PRODUCT BULLETIN

Subject: LP2017 Design Change
Date: 01-07-10
Bulletin Number: 10-0107 LP2017 Design Change

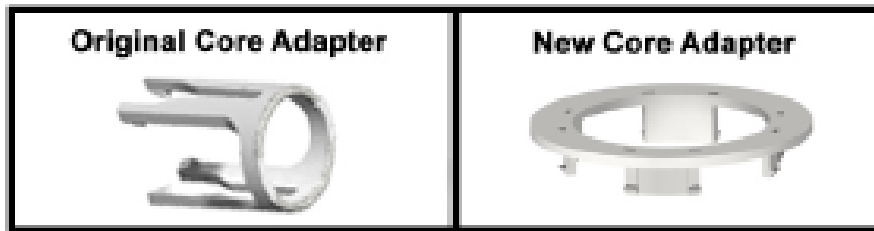
Champion Laboratories, Inc / Luberfiner has initiated a design change on part number LP2017. This is a running change.

LP2017 is now being shipped with the new core adapter and instructions. This new version will fit the 2009 and 2010 Ford Super Duty 6.4L engines as well as all previous application years. The new filter can be identified with the label on the box that says (FITS 2003-2010).

1. A new “Corer Adapter”  is required to service style A housings. (See illustrations above.) To service style A housings proceed to step 2. To service style B housings discard the core adapter and proceed to step 5.

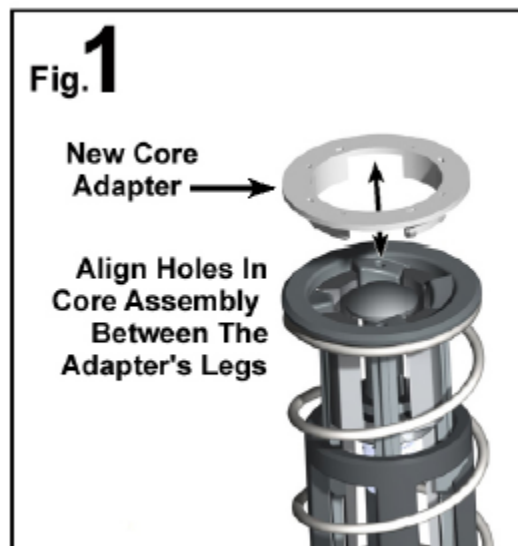
3. Align the holes on top of the core assembly between the legs of the new core adapter. (See Fig 1.)

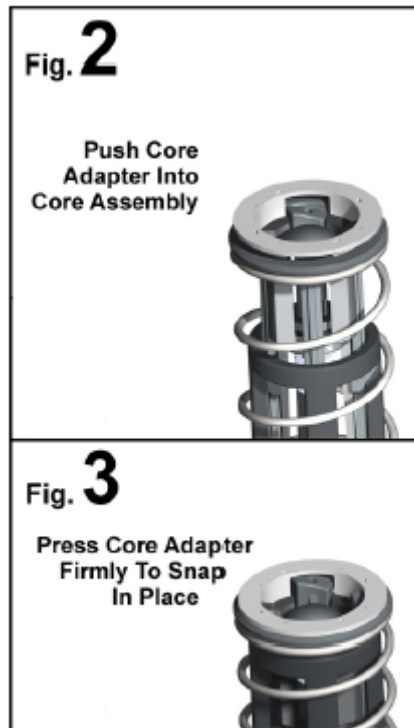
4. With core adapter in position, (see fig 2), press core adapter firmly to snap in place. (see fig. 3)
